# 2 Year Post-Construction Audit

## Tapestry

750 West 12<sup>th</sup> Avenue  
Vancouver, British Columbia

Report No. 5075201.00

Photo 01.JPG

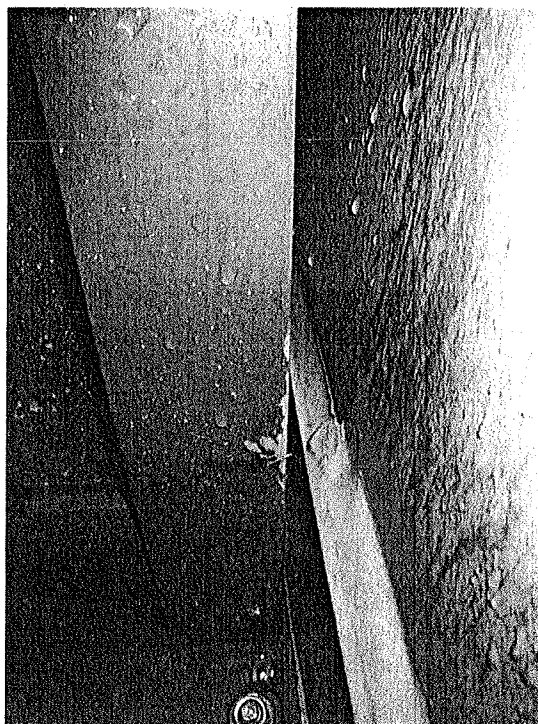
Item/ Photo	Category	Description	Corrective Action
1	M	Unit #404 North Building – A section of sealant installed along the roof deck gum edge flashing is failed (east side of deck)	Removed failed sealant, clean and installed new sealant.
2	M	Unit #405 North Building – A section of sealant installed along the roof deck gum edge flashing is failed (west elevation)	Removed failed sealant, clean and installed new sealant.
3a 3b	D	Unit #404 North Building – Cracks in the concrete are filled with sealant however, no paint is installed to repaired locations. MH understands that this work is in progress.	Paint crack repair areas as required.
4	M	Unit #404 and #405 North Building – A crack has developed along the cold joint (west elevation). The crack is on the under side of the floor slab above and is treated with a water stop treatment.	The crack should be monitored by the strata and repaired if required.

Photo 08a.JPG

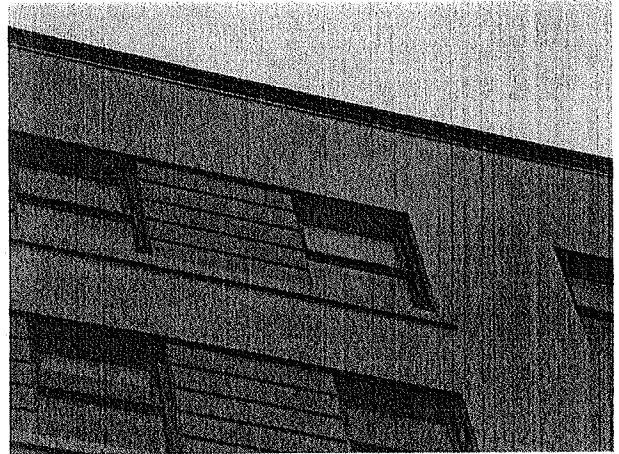
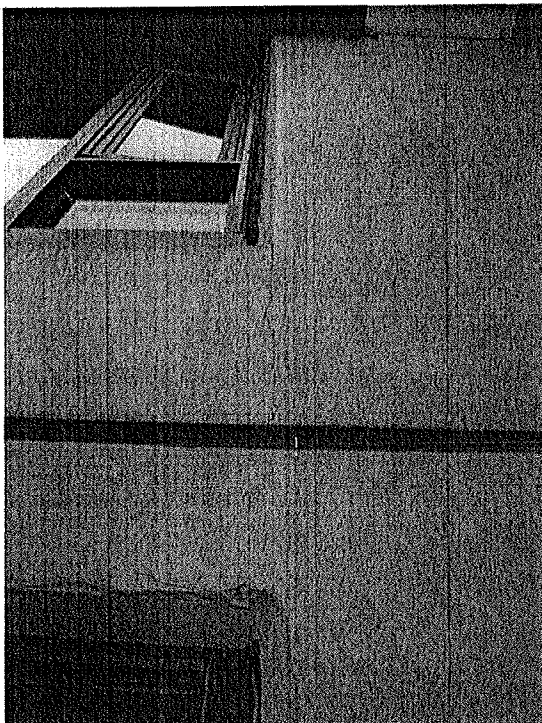
Item/ Photo	Category	Description	Corrective Action
8a 8b	<b>M</b>	Heather Building – Various cracks were observed in the concrete parapets at level 3 and the penthouse (east elevation). MH understands that this façade existing concrete that was retained.	The cracks should be reviewed. Cracks in the concrete should be addressed by routing, cleaning and sealing with caulking. This should be part of the strata's regular building maintenance.
09	<b>D</b>	North Building – A vertical concrete reveal below one window jamb is missing and is cracked. (2 <sup>nd</sup> floor – north elevation).	The crack should be routed, cleaned and sealed with caulking.

Photo 10a.JPG

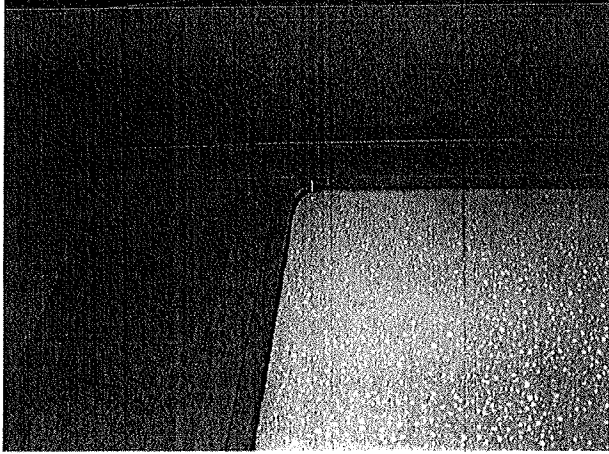
Item/ Photo	Category	Description	Corrective Action
10a 10b	<b>D</b>	Unit #813 and #1007 Heather Building – The exterior gaskets at various spandrel panels are misaligned, have shrunk and pulled out	Reviewed and repair gaskets as required.
11	<b>D</b>	Unit #1007 Heather Building – There is a gap between the window sill flashings on the west elevation (roof deck) and the self adhesive membrane is exposed.	Install a splice plate to close gap and protect membrane from UV.
12	<b>D</b>	Ground Heather Building – Exposed membrane at the sill/jamb transition of one window at the north elevation meeting room.	The membrane should be protected from UV with a cover flashing.
13	<b>D</b>	Unit #202 North Building – Plastic shims are lodged between the window deflection header and the window frame (balcony window).	The shims should be removed to ensure deflection header is continuously sealed to the window frame.

Photo 14.JPG

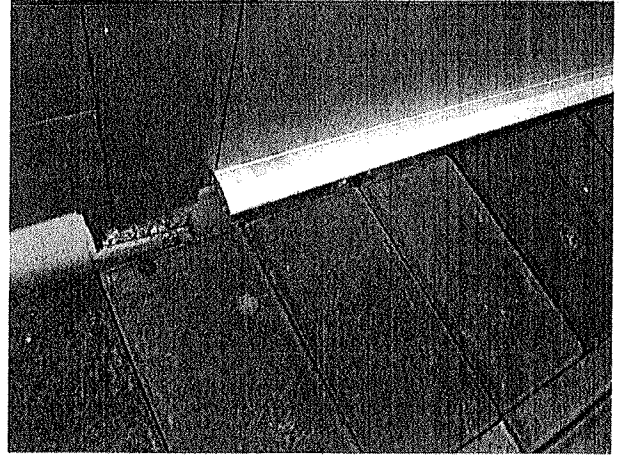
14	<b>D</b>	Unit #404 North Building – The exterior sealant adjacent to the living door roof deck swing door is failed.	The failed sealant should be removed and replaced as required.
15	<b>D</b>	Lobby Door North Building – There is exposed self adhesive membrane along the north elevation lobby door threshold.	The membrane should be protected from UV. A metal flashing can be installed.

Photo 16.JPG

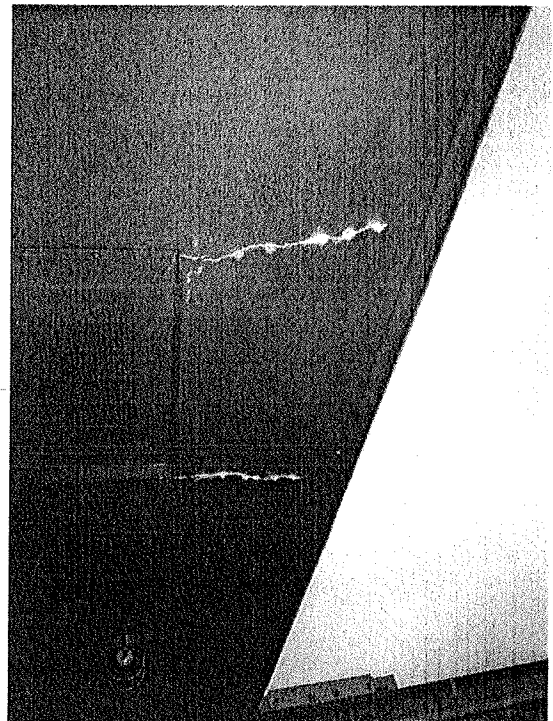
Item/ Photo	Category	Description	Corrective Action
16	M	Exhaust Vents – The vent screens at most locations are blocked with lint/debris. This is typical for both buildings.	Dryer ducts should be reviewed and cleaned on a regular basis as outlined in the maintenance manual issued to the strata.
17	M	North Building – Hair line cracks were observed on the under side of the upper soffit, typically at exhaust vents. Condensation from the vents collects along the cracks and deposit efflorescence making them highly visible.	This is cosmetic only. Clean as required. Keeping vents clean will reduce instances of condensation.
18	D	Unit #1007 Heather Building – Missing membrane was observed at the eyebrow slab edge where the decorative vertical steel column by-passes the slab.	Paint slab edge as required.

Photo 20.JPG

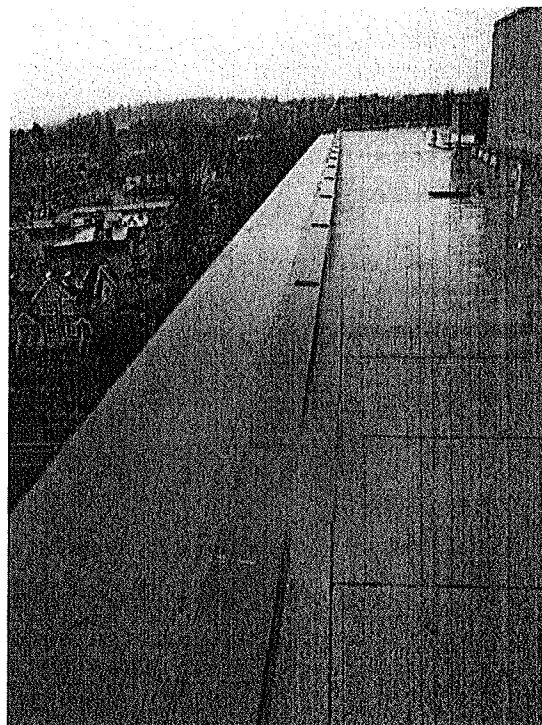
Item/ Photo	Category	Description	Corrective Action
20	I	Mech. Room Heather Building – An area of roof membrane granular (UV protection) is damaged.	New granulars should be applied to the damaged area to protect the membrane from UV.
21a 21b	M	Heather Building – Some occupants on level 10 have reported water draining over the edge of the roof and is concentrated at various locations.	The eyebrows (~2ft wide) above level 10 are sloped to the exterior and drain over the edge. The strata can install gutters along the roof edge to collect the water if desired.
22	M	North Roof – Vegetation is growing in the gravel buffer zone between the green roof and the exterior walls and parapet walls.	Gravel areas on the green roof area should be reviewed periodically. All vegetation should be removed from gravel areas.
23	I	North Roof – The gravel ballast was removed from all drain locations exposing the roofing insulation. UV exposure will degrade the insulation over time.	The insulation should be protected from UV, however the drains should be visible so regular maintenance can be provided.
